# UNITED STATES PATENT AND TRADEMARK OFFICE

| APPLICATION NO.   | FILING DATE | FIRST NAMED INVENTOR | ATTORNEY DOCKET NO. | CONFIRMATION NO. |
|---|-------------|----------------------|---------------------|------------------|
| 10/649,105  | 08/26/2003  | Peter G. Webb        | 10004004-3          | 5480             |

| <b>Office Action Summary</b> | <b>Application No.</b> | <b>Applicant(s)</b> |  |

## **DETAILED ACTION**

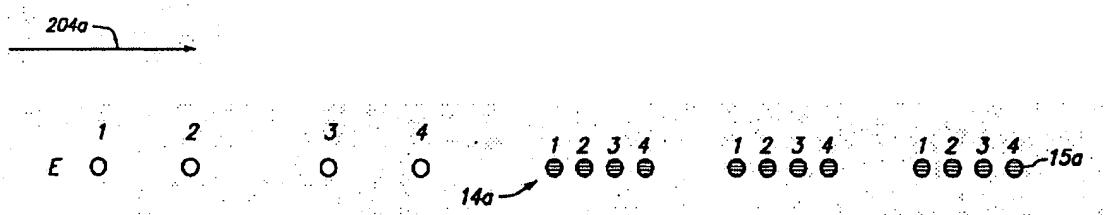
Claim 20, step (c) recites the phrase, "each dispenser set depositing a drop set at a distance ahead of a drop set deposited by a preceding dispenser set...."

This limitation is confusing in view of what is being disclosed in the specification.

Figure 4A of the specification, when describing the first pass of the head system comprising multiple successive sets of dispensers, discloses that dispenser set E, while moving in direction 204(a) (or to the left direction), dispenses from dispensers 4, 3, 2, 1, in that order. For clarity the Figure is reproduced below:

Hence, for example, dispenser 3, deposits a drop set at position 3, which is not "ahead" of the drop set deposited by dispenser 4 (which is the preceding dispenser) but "behind" the drop set deposited by the preceding dispenser.

The claims are in contradiction to that which is disclosed in the instant specification and clarification is required.
